## Memorandum

### Memorandum #13-63

Subject: SR A1A Reconstruction Project from North of Sunrise Blvd to SE 18<sup>th</sup> Street  
FPID #- 433688-4-52-01

07/31/13 Long Plot of current SR A1A Reconstruction Design Plan

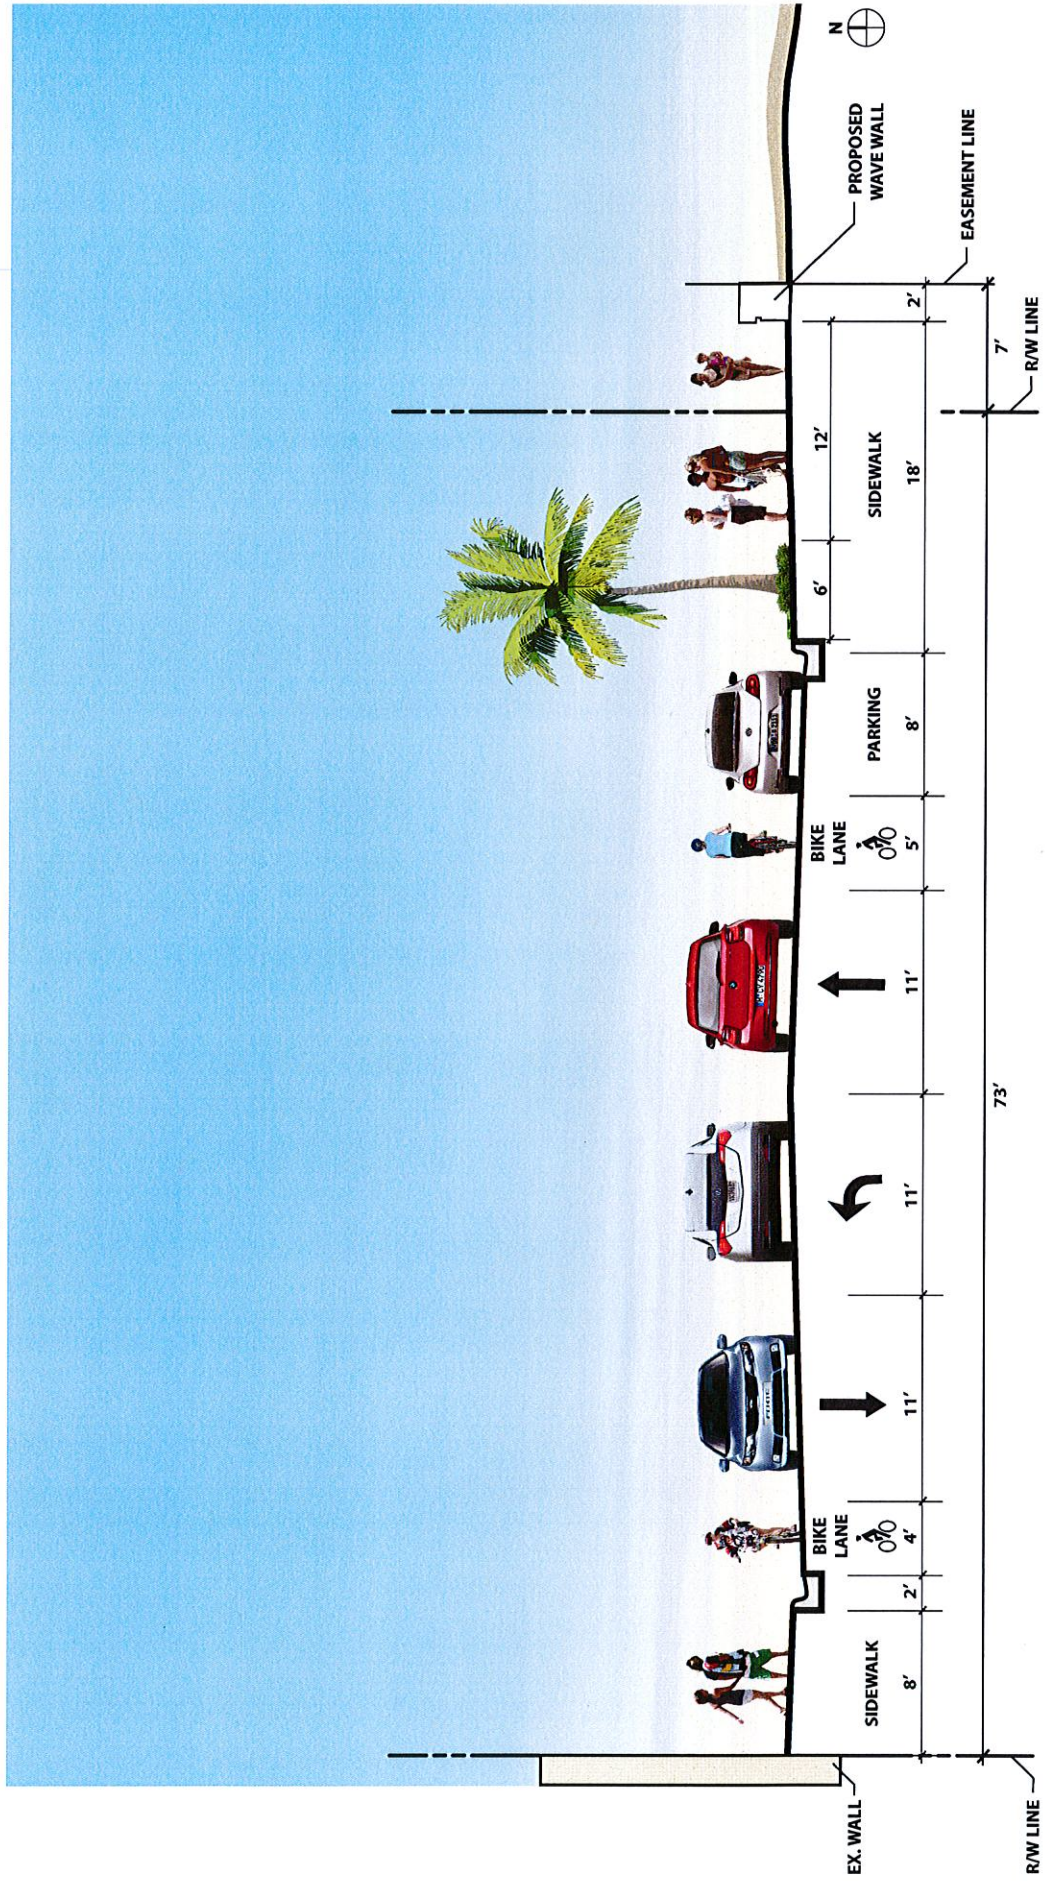
- Still requesting raised medians instead of continuous northbound right turn lane at certain blocks identified in our July 25, 2013 letter to FDOT District IV Secretary.

- Adjust the beach opening from Station 254+00 to 253+00
- Provide an enhanced signalized crosswalk at Station 253+00 (installation of in pavement LED lights triggered by pushbutton controller); this will require loss of approximately two parking spaces on the east side and two parking spaces on the west side.

- Provide pedestrian mast arm signals at the intersections of Birch Park access, 14<sup>th</sup> Court, 16<sup>th</sup> Street and 17<sup>th</sup> Street. This is a slight revision to the where the mast arms were previously installed prior to the damage along SR A1A.

- Need confirmation of plan for permanent tunnel closures at Birch Park (244+50) and at Station 260+40. If these tunnels are permanently closed, the structures associated with them at beach level should be removed.

- Need copy of drainage report with specifics regarding the proposed drainage basins for the new surface water collection system; need specifics on the outfall for this stretch of SR A1A.
- Need clarity on the proposed pedestrian lighting infrastructure that will be included in the scope of work for this project (similar to South Beach Park, Amber Lighting per Fish and Wildlife, etc.)
- Proposed Landscape Design:
  - Replace Sylvester Palms with Majewel Palms at beginning and end of Birch Park Median Stretch of SR A1A
  - Remove Silver Buttonwood Trees and replace with Silver Buttonwood hedge
  - Addition of 36" high decorative aluminum fence within the median along the Birch Park Median Stretch of SR A1A to deter pedestrian crossings at undesignated locations
  - Addition of Coconut Palms along the east side of the wave wall for additional streetscape
